**Historic Architectural Review Commission
Staff Report for Item 5a**

Application Number: H15-01-1528

Address: #1301 Whitehead Street

Description of Work:

Proposed Side (United St.) Elevation

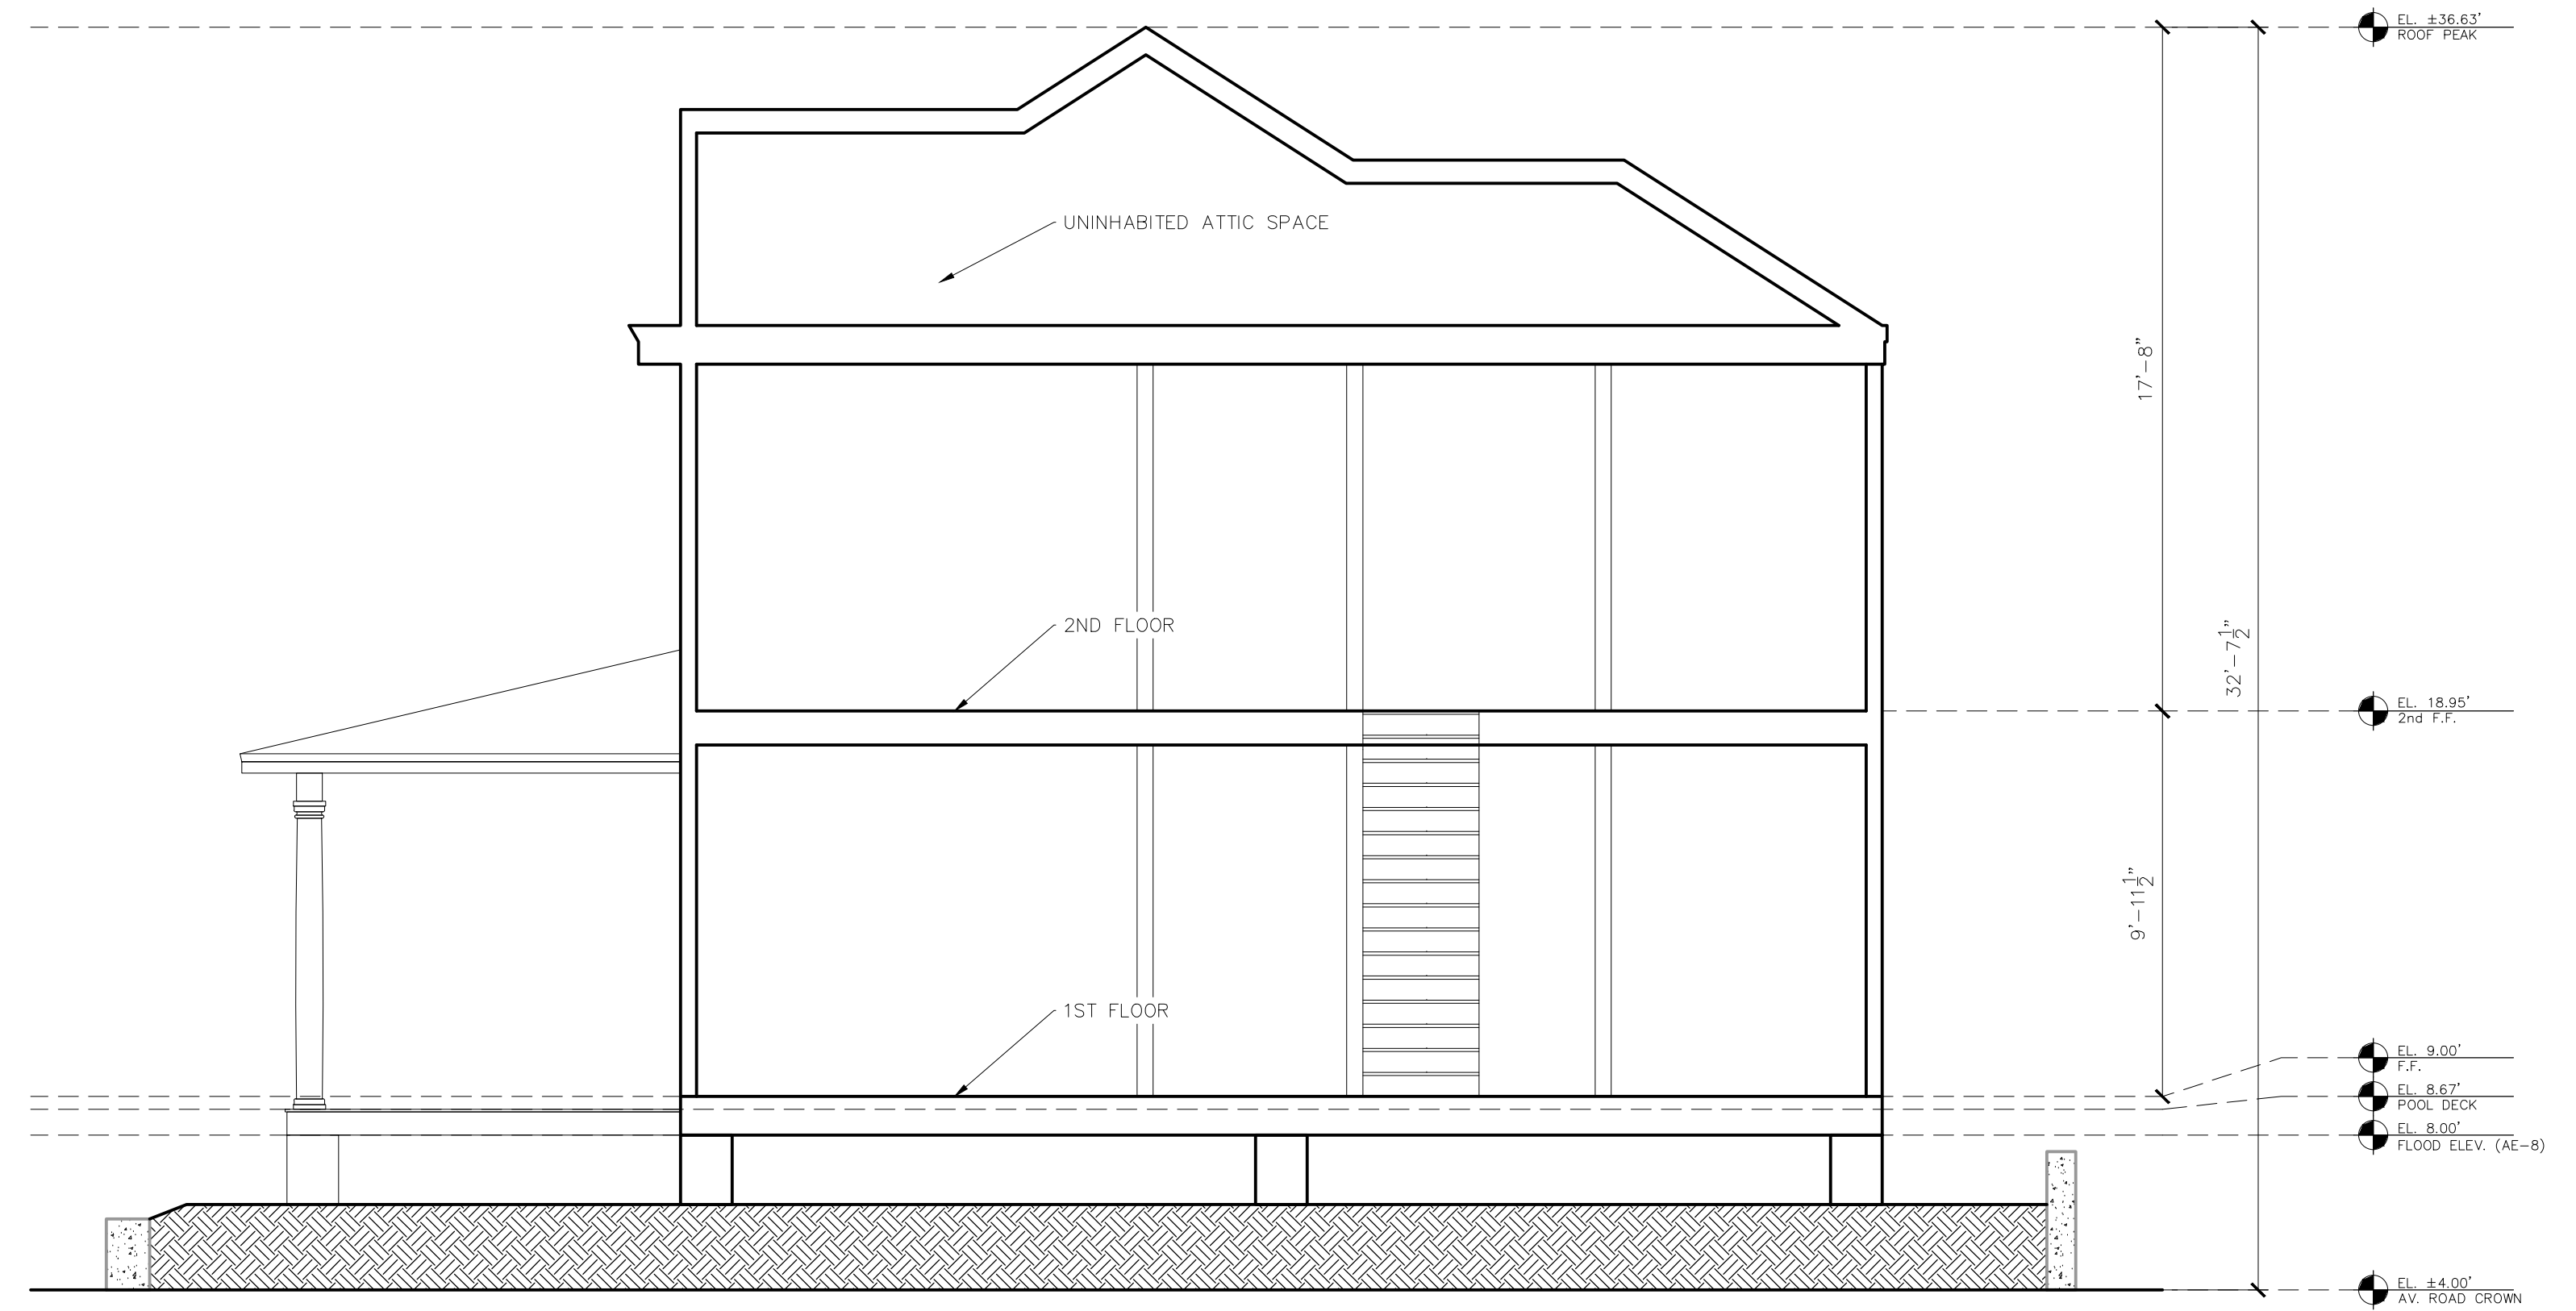
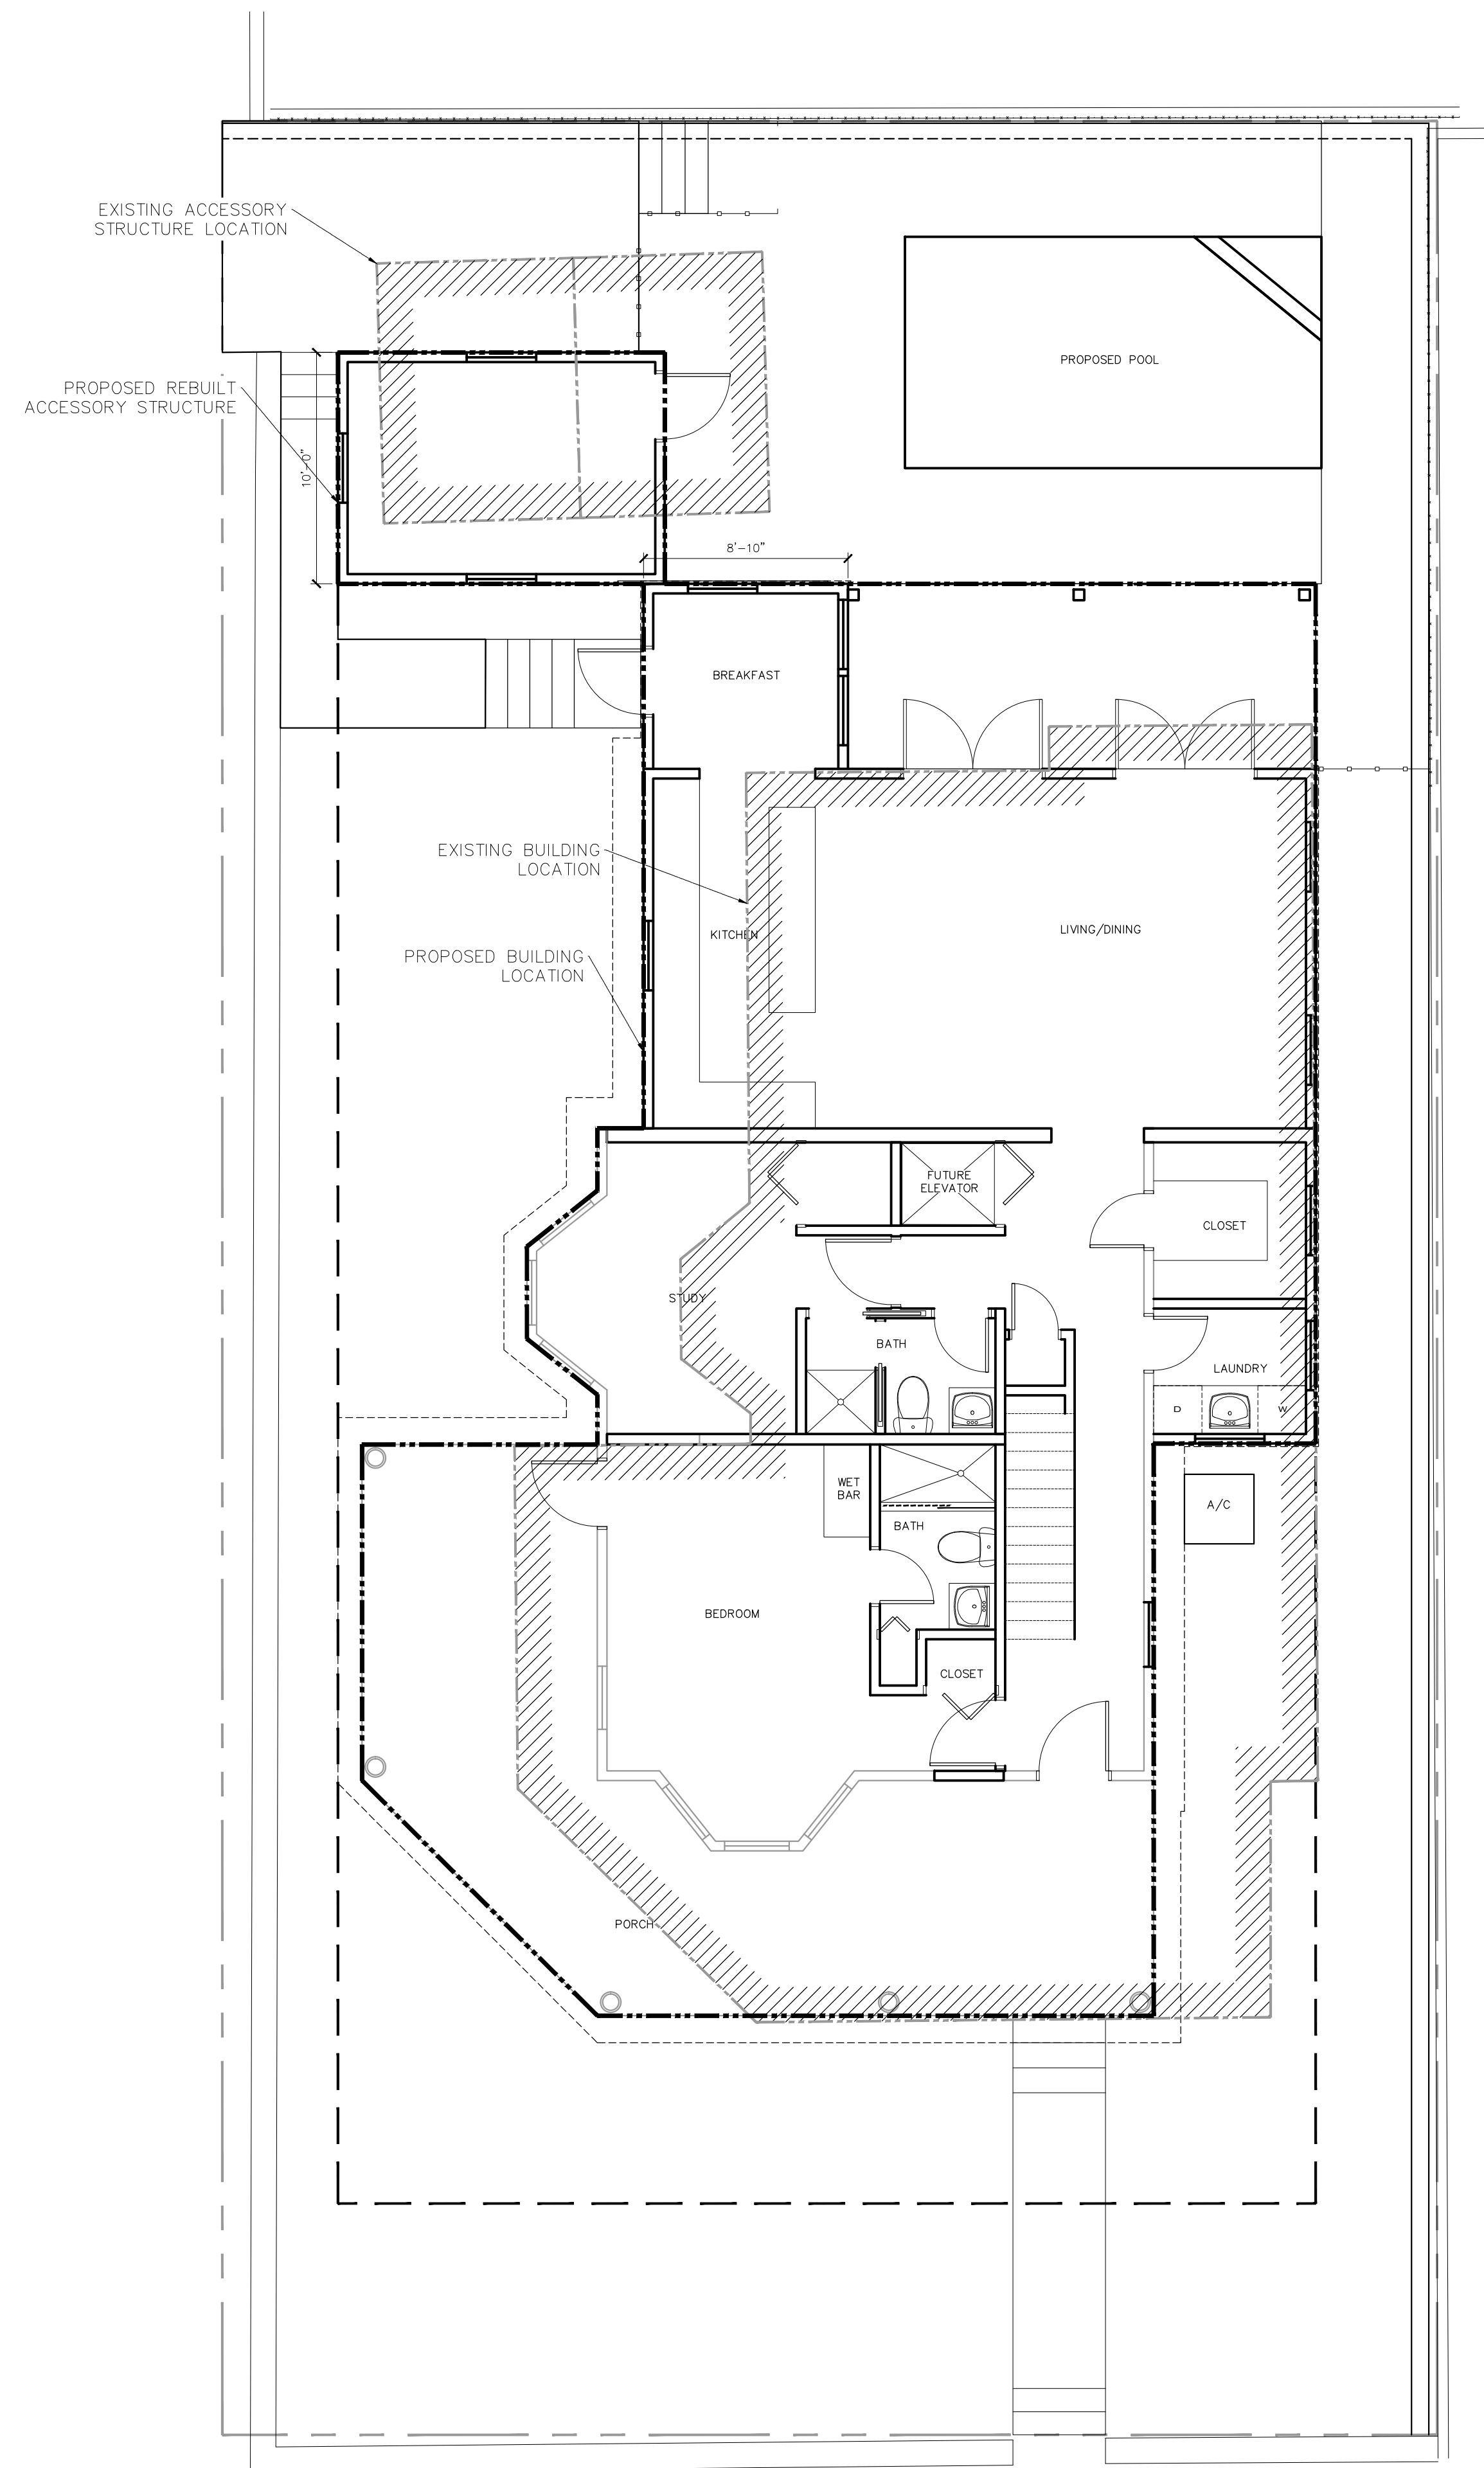
The proposed rear and side addition will be visible from United Street, and less visible from Whitehead Street due to dense vegetation (guideline 5-p.37). Although the addition will be lower in height than the existing main house, it will encroach most than half of the south façade disrupting the balance and symmetry of the historic house (guidelines 4 and 6-p.37). The design for the south facade incorporates different roof forms towards that helps breaking the mass of the addition, still the side addition obscures the majority of the existing façade. (SOIS 1 and 2-p.16-23, guideline 8-p.37). The design proposes the removal of the historic south rear portion of the house.

The proposed elevation of the new addition towards United Street has an appropriate scale, mass, and height in relationship to the existing house and surrounding buildings. The façade is slightly setback from the existing north façade and reads as an addition. (guideline 8-p.37)
